CITY COUNCIL ACTION FORM

Resolution 2024-45: Public Hearing for Consideration of Approval of the Shaken Roost Major Subdivision.

TYPICAL LOT SET-BACKS
ILLINOIS AVENUE

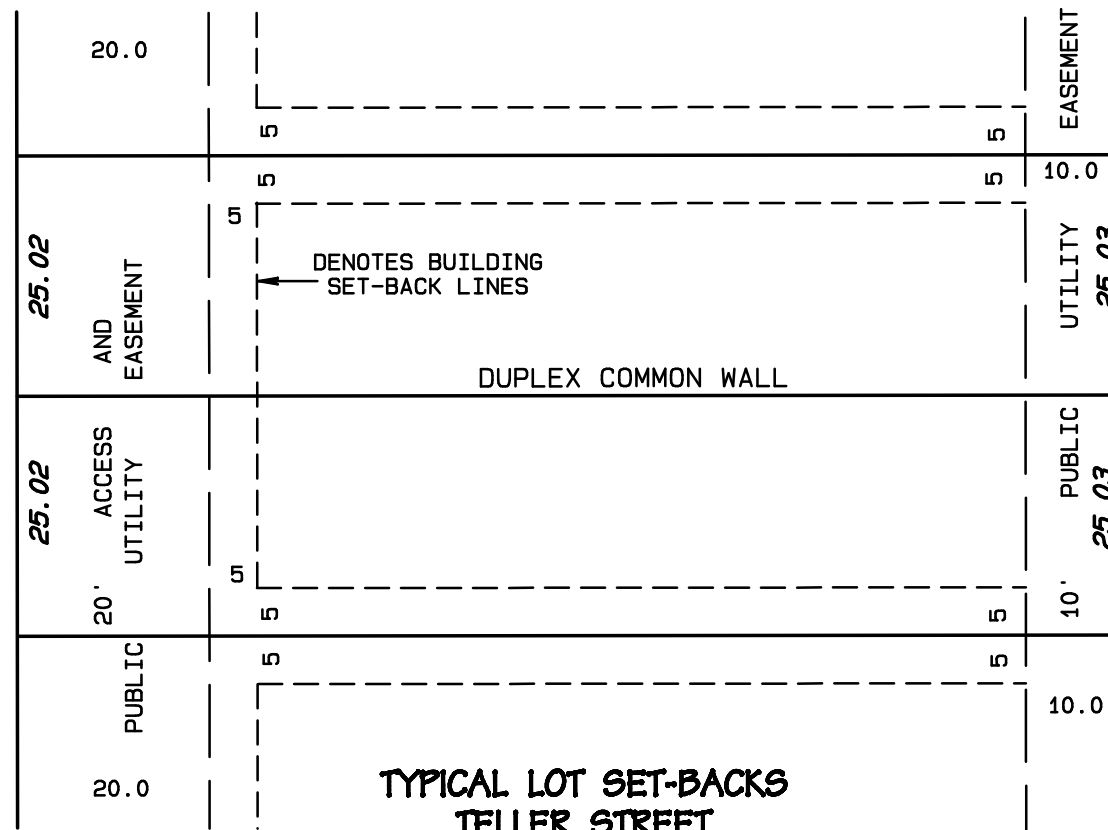
4) Private access ways are included as a part of each lot. Staff is requiring the rear yard of five feet be applied to the edge of the access way to allow easier vehicle access and to keep structures out this drive as shown here.

- The off-street parking requirement of one space for each unit must be met.
 - Staff is recommending the rear setback be north of the private access way for Lots 1-8; and east of the access way for Lots 9-14 as described under Observation #4, and now a part of the proposed Resolution as attached Exhibit B.

UTILITY PLAN

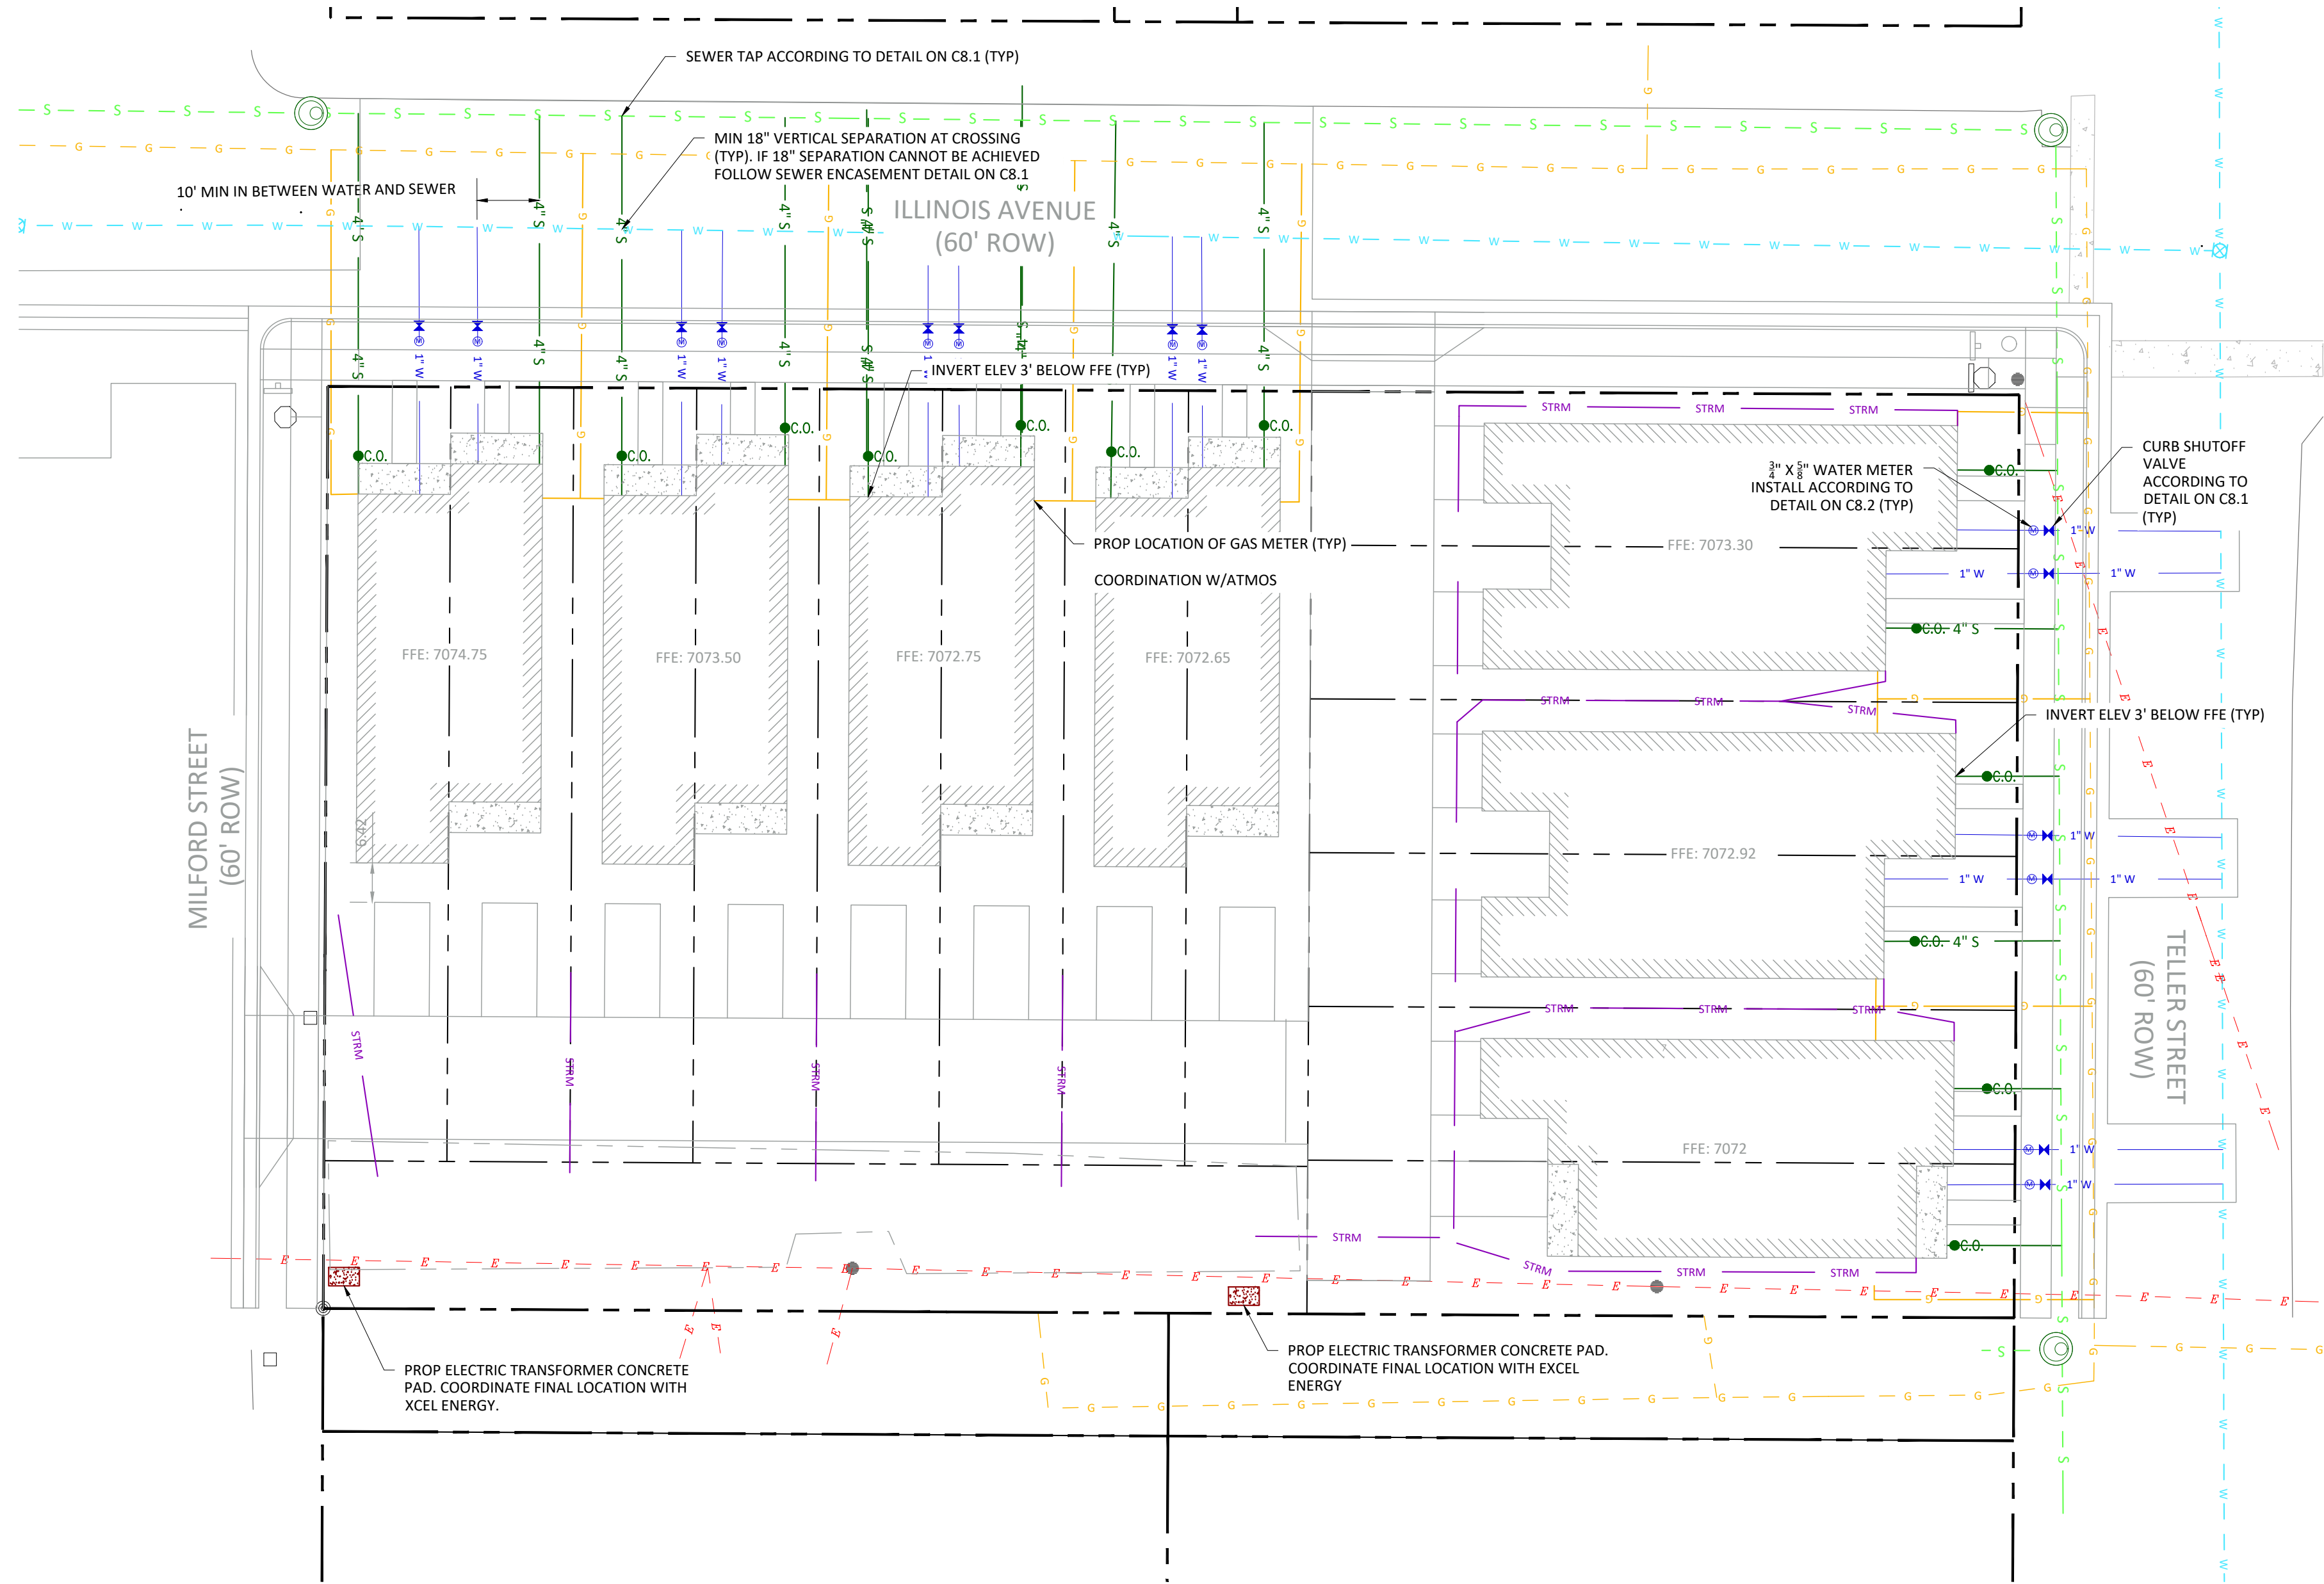
Prior to the customer/developer's application to our Builder's Call Line, instructions were given to build 7.5-feet away from PSCo's existing power lines (NESC code) and to keep all equipment and people 10-feet away from the power lines (OSHA). It does not appear that these changes were made on the plan and are not maintaining proper clearances from the existing primary lines. It also appears that the transformer locations are not what was discussed.

To serve individual units, the unnamed track needs to be labeled as a PUE allowing you to provide service to individual lots. Where are the service drops? What is the proposed use of this track? Is for access or additional parking? If this is for excess parking, protective bollards need to be provided by the developer.
